Addendum No. 2
Page 1 of 6

TO: Prospective Respondents
SUBJECT: Addendum No. 2
PROJECT NAME: Renaissance Center Interior Renovations
JJC PROJECT NO.: B16008

ADDENDA TO THE PROJECT MANUAL:

E2.10

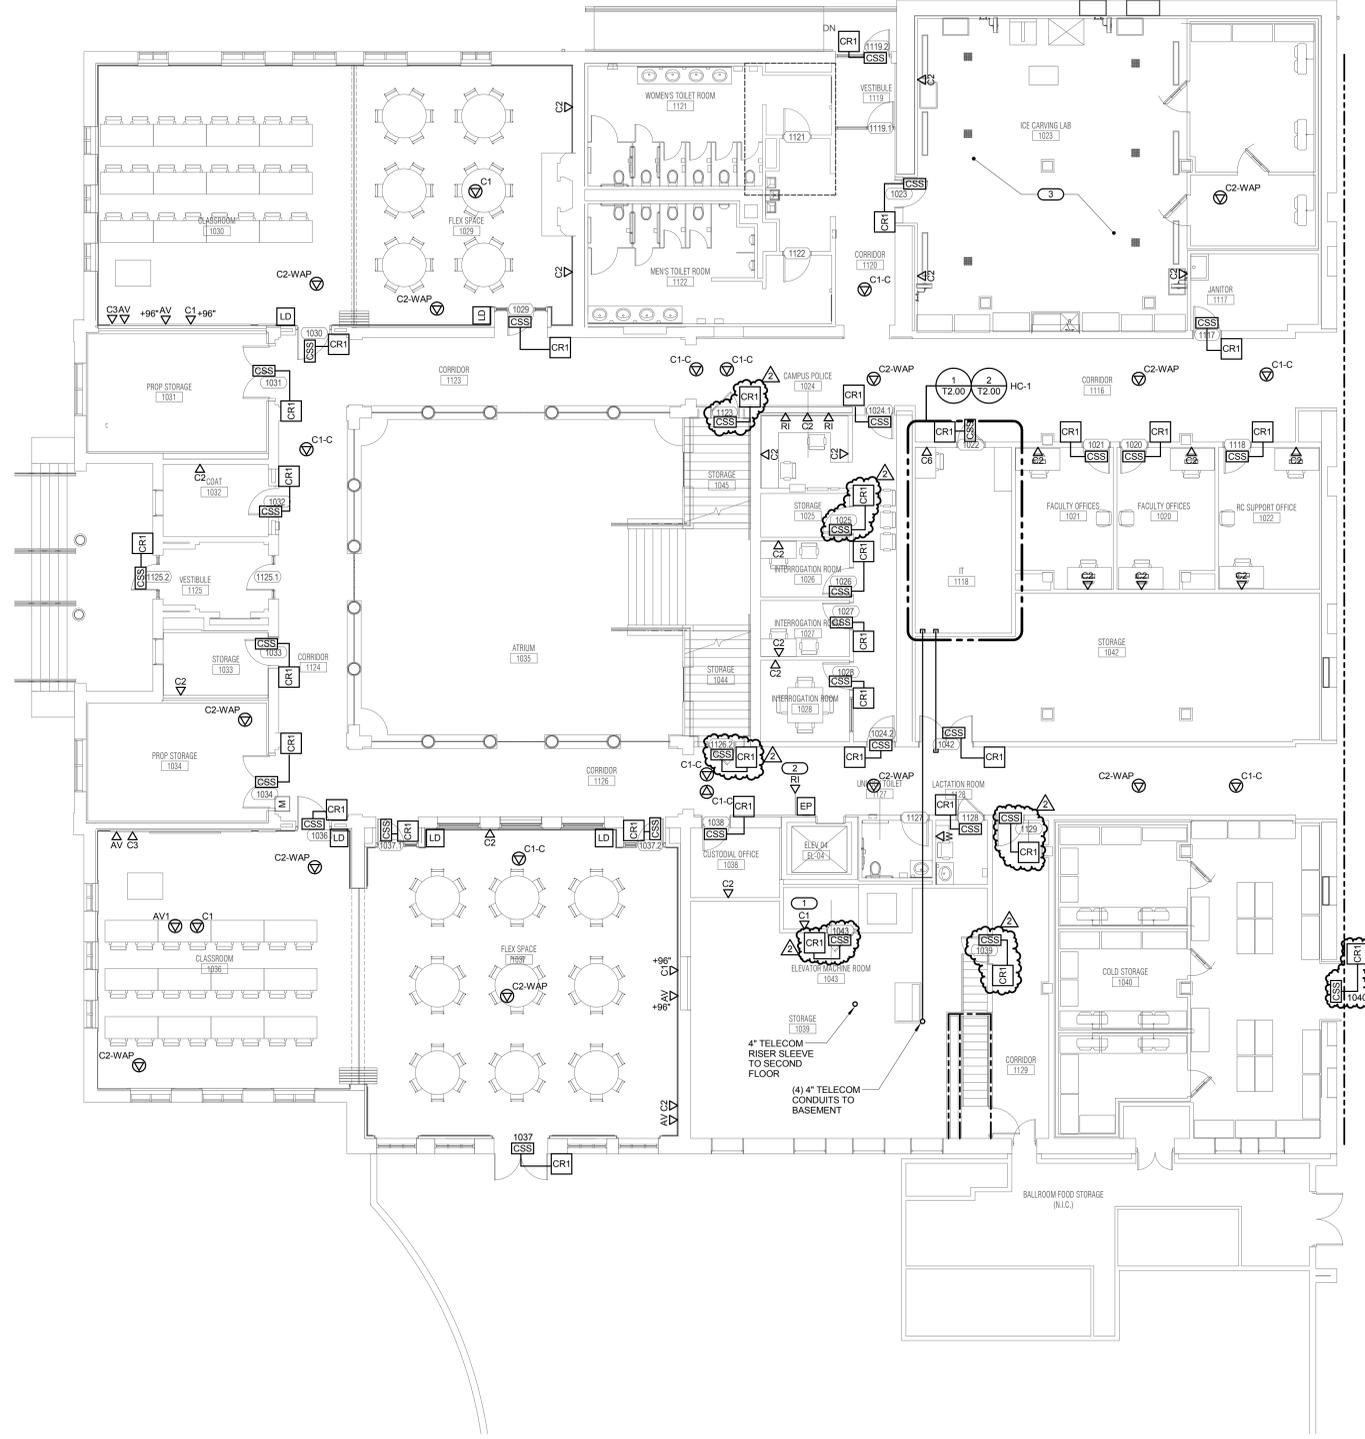
- 3) **ADD** keynote #6 to room STORAGE 2019.
- C. Sheet E2.10
- 1) **REVISE** receptacle circuit in ELEVATOR MACHINE ROOM 1043.
 - 2) **REVISE** receptacle location in INTERROGATION ROOM 1026.

- 3) **REVISE** receptacle location in INTERROGATION ROOM 1027.
 - 4) **REVISE** receptacle location in INTERROGATION ROOM 1028.
 - 5) **REVISE** circuit for receptacle along column line 8 in CORRIDOR 1116.

- 6) **REVISE** circuit for receptacle along column line 8 in CORRIDOR 1126.
 - 7) **ADD** circuit to electrical connection for CH-2 in VESTIBULE 1125.

- 8) **ADD** circuit to electrical connection for CH-1 in VESTIBULE 1119.
 - 9) **ADD** electrical connection for hand dryer, sink, and toilet in UNI-SEX TOILET 1127. **REVISE** receptacle location to north wall.

- 10) **ADD** electrical connection for hand dryer and sink in LACTATION ROOM 1128. **REVISE** location and mounting height of receptacle on west wall.

- 11) **REVISE** circuit for WH-1 in JANITOR 1117.
- D. Sheet E2.20:
- 1) **REVISE** circuit for receptacle along column line K in BAR 2110 from "R2L3-6" to "EQR0L1-1".

SHEET NUMBER:
T1.10

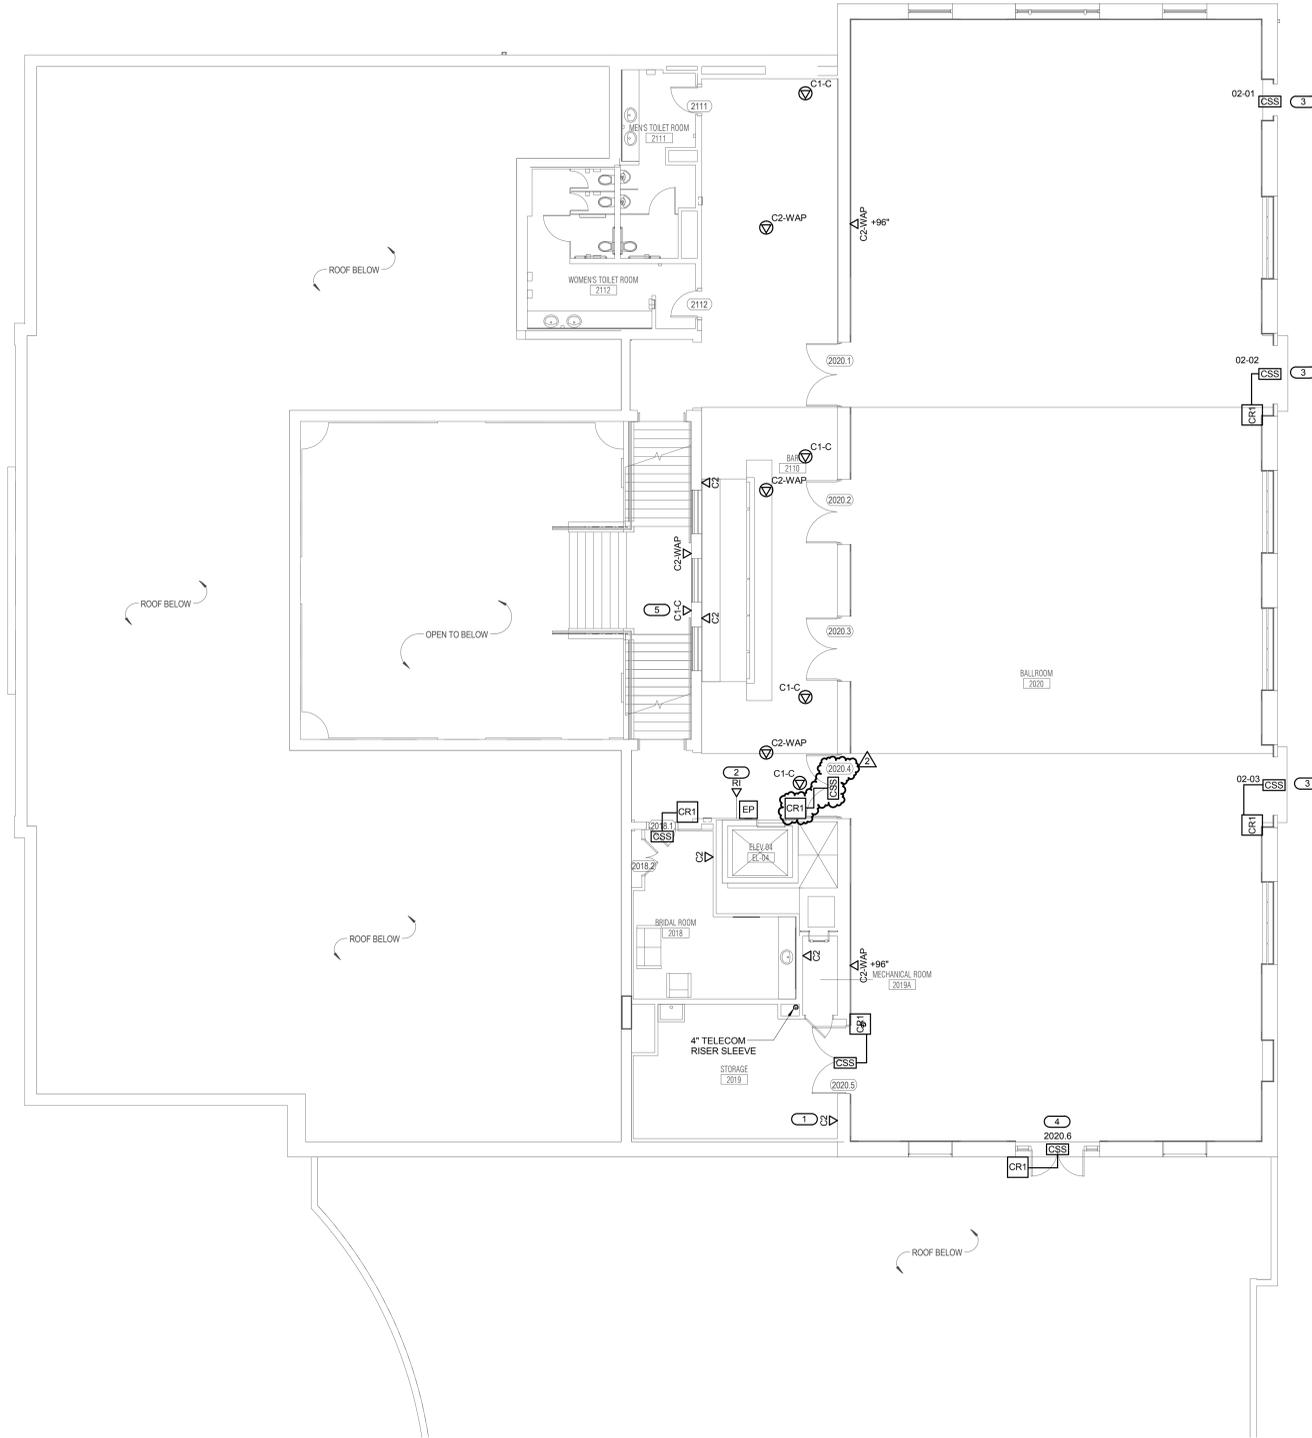
- 1) **ADD** Card Reader rough-in and wiring to Storage room 1044.
- 2) **ADD** Card Reader rough-in and wiring to Elevator Machine Room 1043.
- 3) **ADD** Card Reader rough-in and wiring to Corridor 1129.
- 4) **ADD** Card Reader rough-in and wiring to Storage Room 1025.
- 5) **ADD** Card Reader rough-in and wiring to Storage Room 1045.
- 6) **ADD** Card Reader rough-in and wiring to Kitchen Storage 1040.

ROOF MOUNTED
 REFRIGERATION
 RACK DETAILS

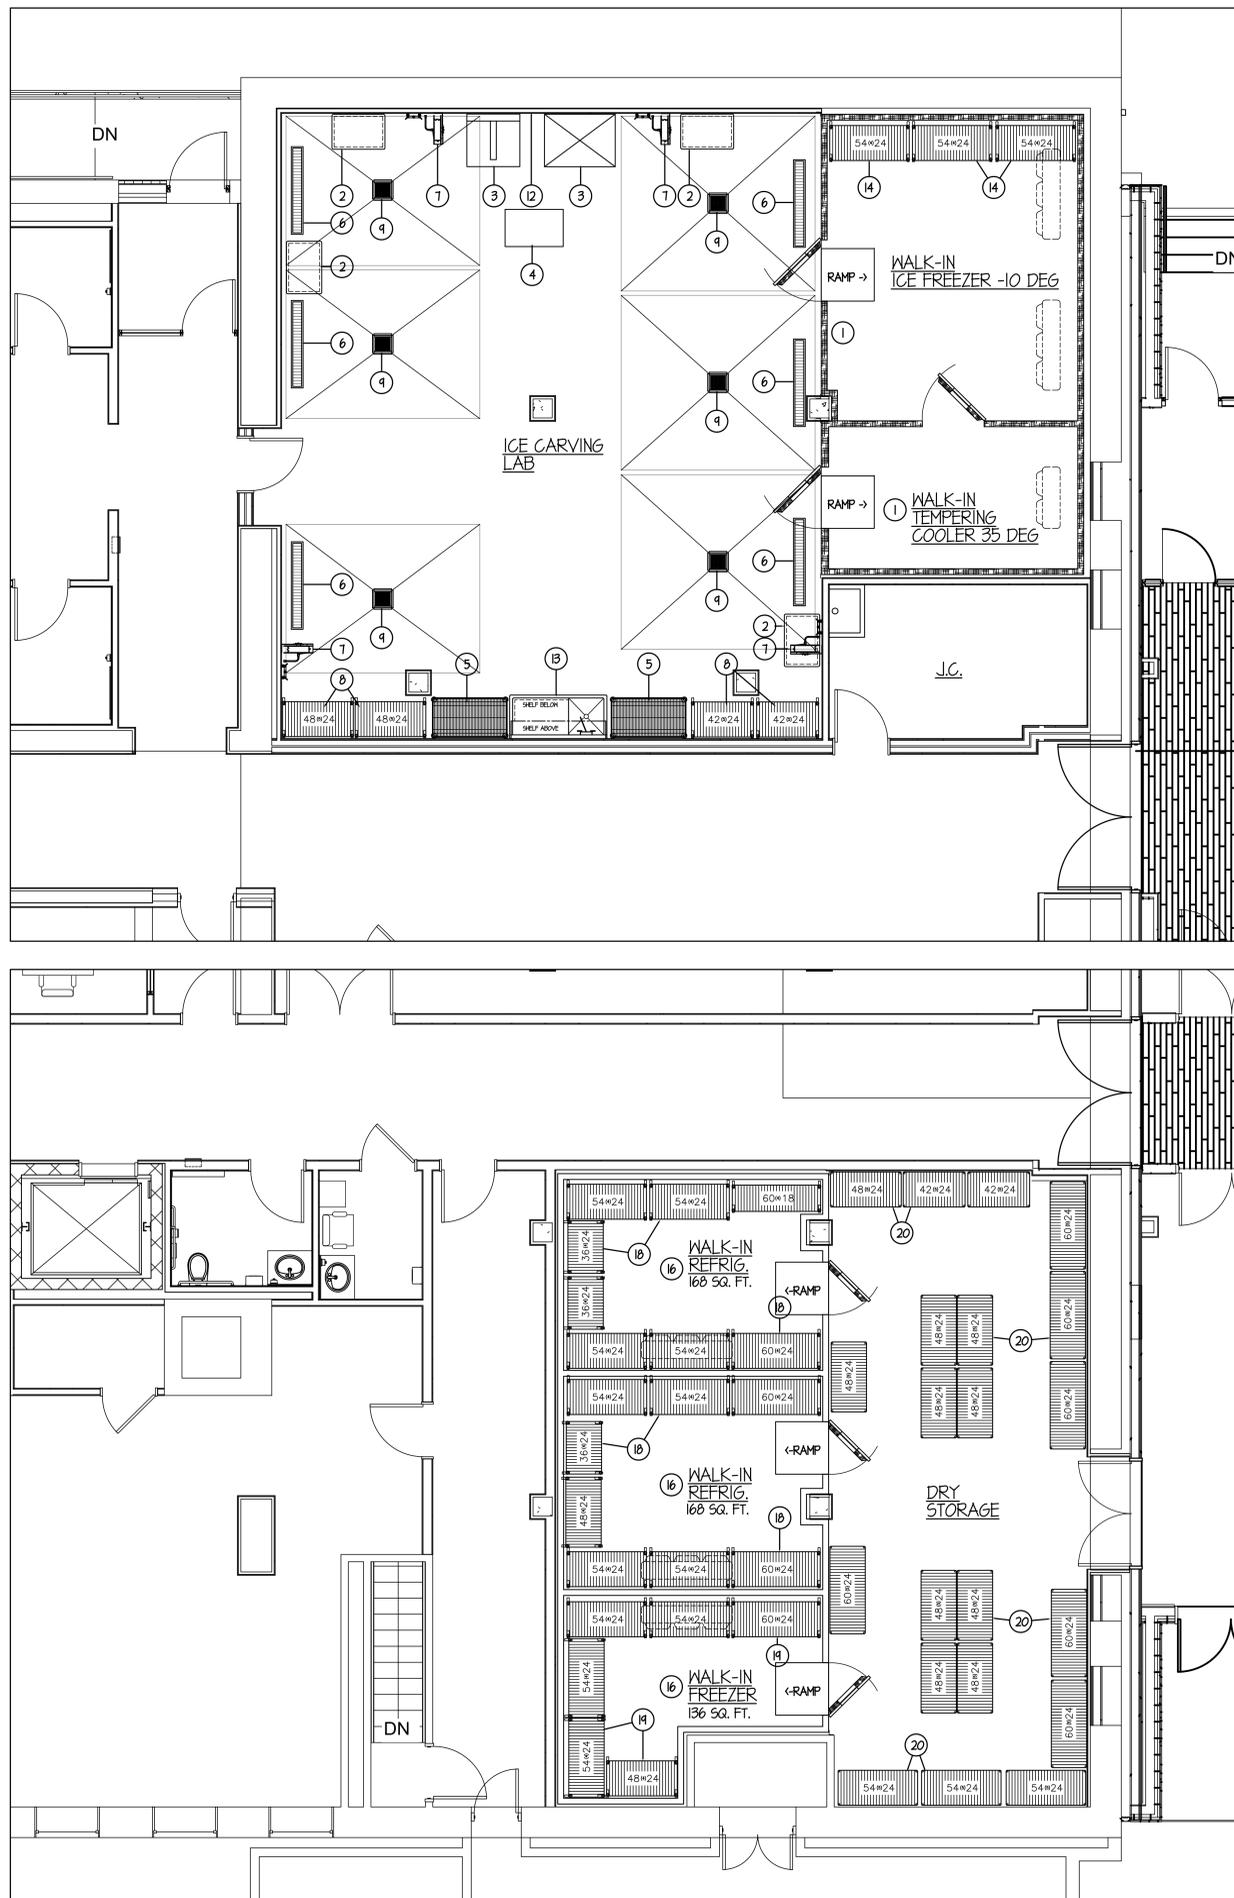
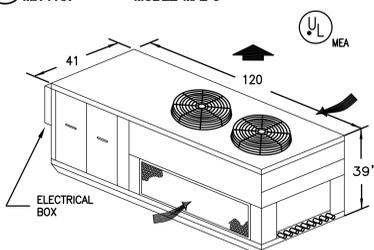
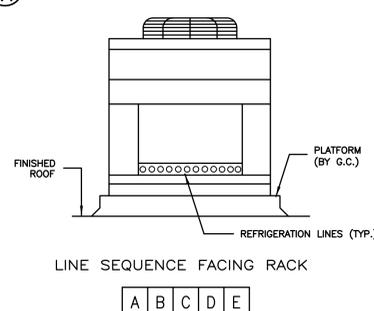
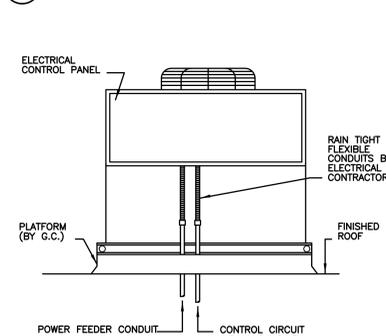
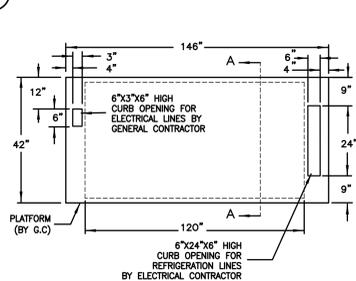
- A. **FSE 1, FSE 2, FSE 3, FSE 4, FSE 5:** **ADD** the attached sheets to the drawing set.
